# INNER WEST COUNCIL

## DEVELOPMENT ASSESSMENT REPORT

<b>Application No.</b>	DA201800560
<b>Address</b>	437-439 Illawarra Road, Marrickville
<b>Proposal</b>	To demolish part of the premises and construct a 6 storey mixed use building comprising 2 commercial tenancies on the ground floor and residential units above with associated basement parking
<b>Date of Lodgement</b>	24 December 2019
<b>Applicant</b>	C D Architects P/L
<b>Owner</b>	Mrs Antoinette Elias & John Elias
<b>Number of Submissions</b>	2
<b>Value of works</b>	\$5,191,754
<b>Reason for determination at Planning Panel</b>	SEPP 65
<b>Main Issues</b>	Room sizes CPTED
<b>Recommendation</b>	Approved with Conditions
<b>Attachment A</b>	Recommended conditions of consent
<b>Attachment B</b>	Plans of proposed development

Figure 5: Conceptual massing sketch provided by AEP during the Pre-DA.

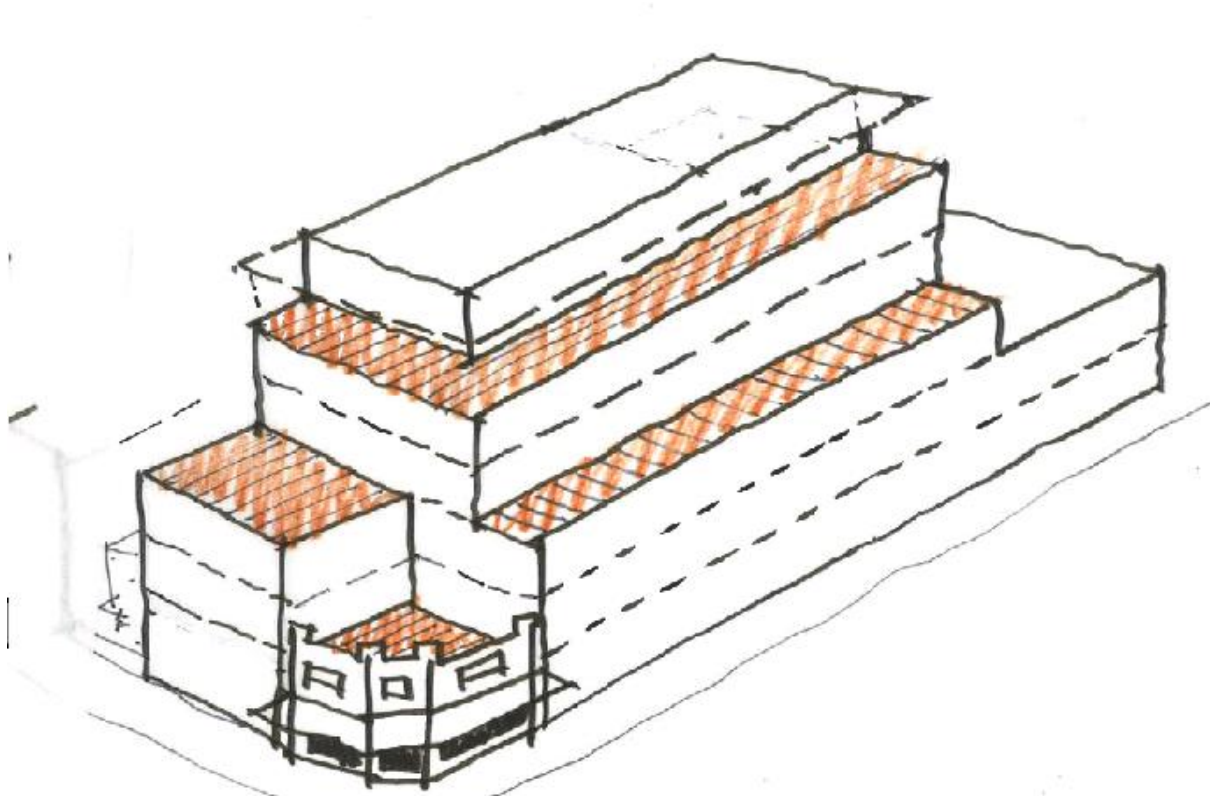
Issue: The proposal is not consistent with the Pre-DA sketch (see figure 5) in that it does not provide a two-storey built form to the east.

Comment: The two-storey element shown on the sketch is the adjoining two-storey structure at No. 55 Warren Road. This was included in the sketch to provide context. As discussed elsewhere in this report, the proposal is acceptable having regard to setbacks and massing.
